GS4GG Verification (Performance) Certification Report

**50 MW Mahoba Solar PV Power Project by M/s
Prayatna Developers Pvt. Ltd. at Mahoba, UP**

Registry Project ID: 7137

VKU.VER.45.25_GS_7137

Figure: Location on google earth pro of the new geo-coordinates of the project activity

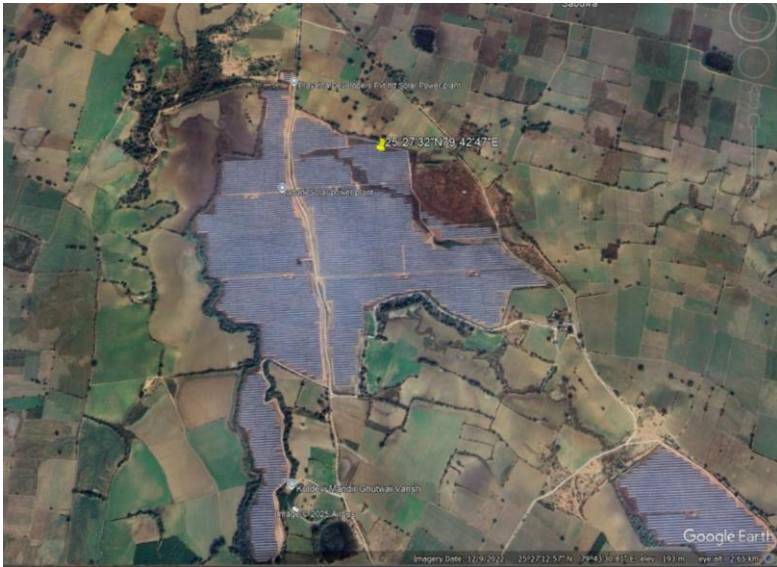
Type of change(s)	Corrections		
Description of change(s)	In the registered PDD, the geocoordinates were incorrectly stated. During the current monitoring period (01/01/2021 to 15/11/2023, both dates included), the project location coordinates have been corrected. The latitude and longitude mentioned under Section A.2 of the MR have been revised to accurately reflect the actual location of the project site.		
Assessment of change(s)	The PD has mentioned the new geocoordinates of the project activity in the section A.2 of the MR.		
	Geo-Coordinates	Latitude	Longitude
	Geo-coordinates mentioned in registered PDD	25°24'00"N	79°42'00"E
	New Geo-coordinates	25°27'32"N	79°42'47"E
	The assessment team has reviewed and cross verified the new geo-coordinates through google earth software during desk review /34/ and onsite visit and found correct.		
Opinion on change(s)	The VVB confirms that this correction relates only to the clarification of the solar project location and does not impact any key parameters, the applicability of the selected methodology, additionality, or the appropriateness of the baseline scenario as established during the validation. Therefore, the change is accepted by assessment team.

The assessment team has reviewed this correction and cross verified the new geo-coordinates through google earth software during desk review and onsite visit/34/ and found correct. The assessment team has further reviewed and confirmed that this correction does not have any impact on any parameter of the project, the applicability of the methodology, additionality or the appropriateness of the baseline scenario established during the validation of the project. Hence, this correction is accepted by the assessment team.
--	---
